Must disconnect the three shown pins between MK3 J4 and A810 J6:

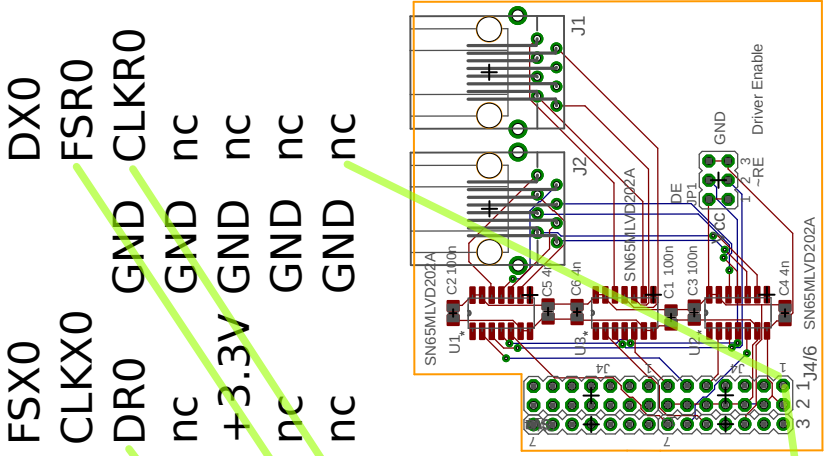
CLKR0,
FSR0,
DR0

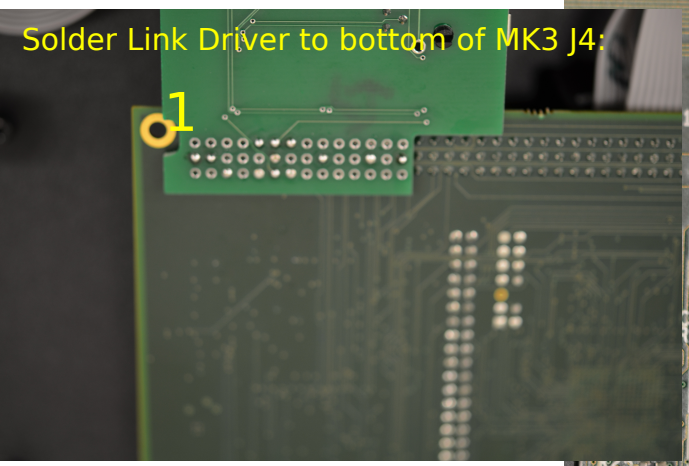
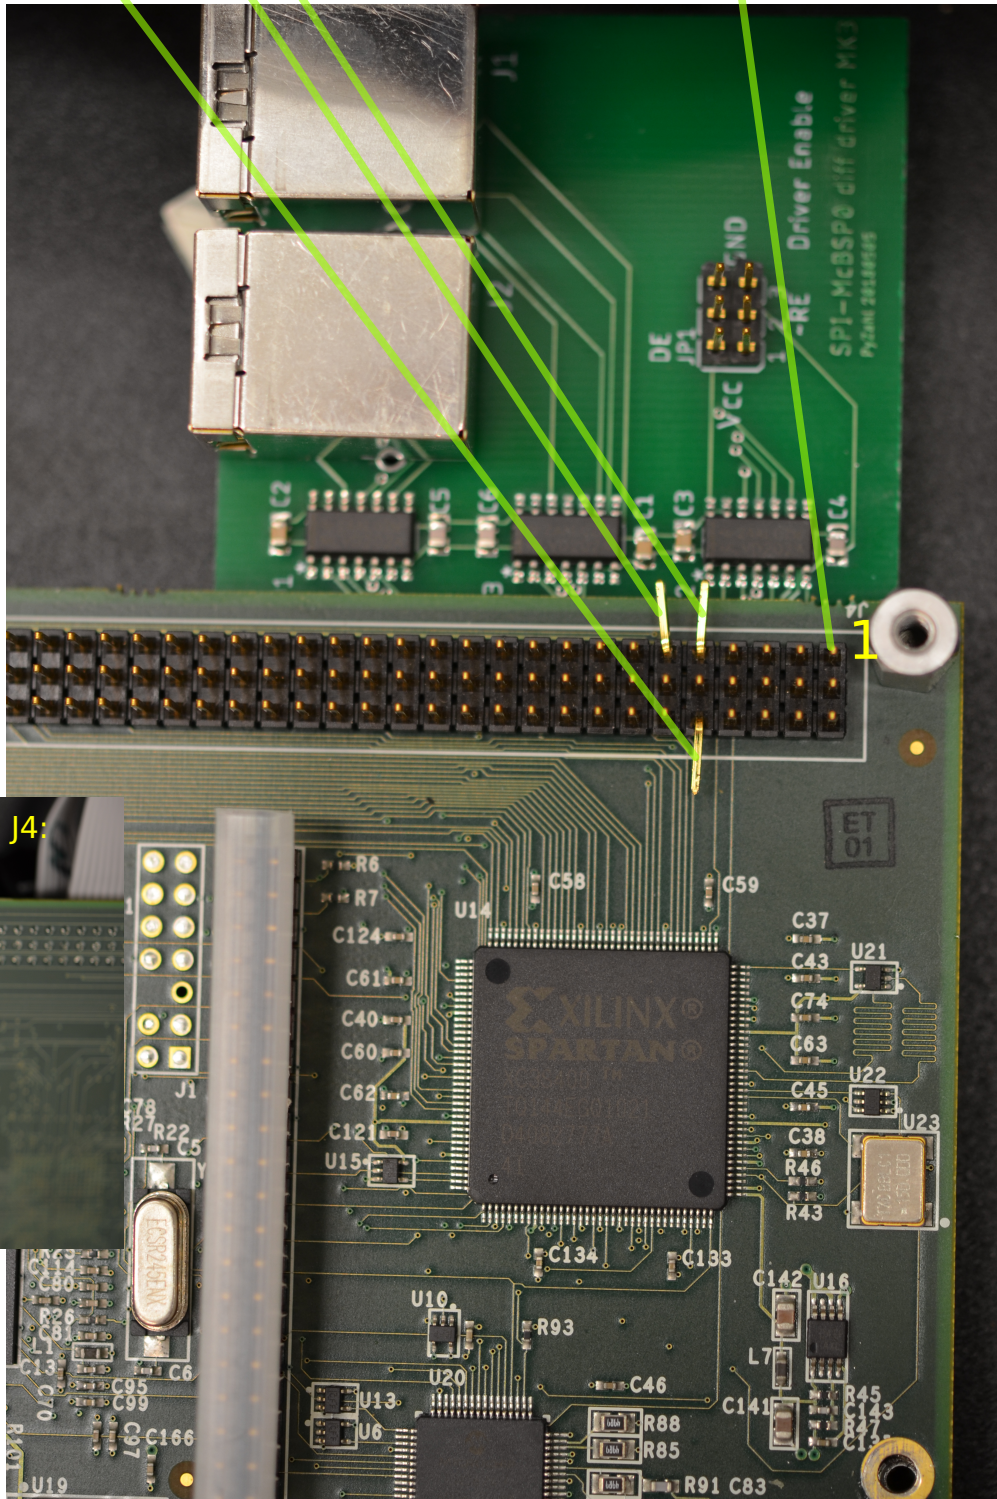
Simply bending them sideways does the trick!
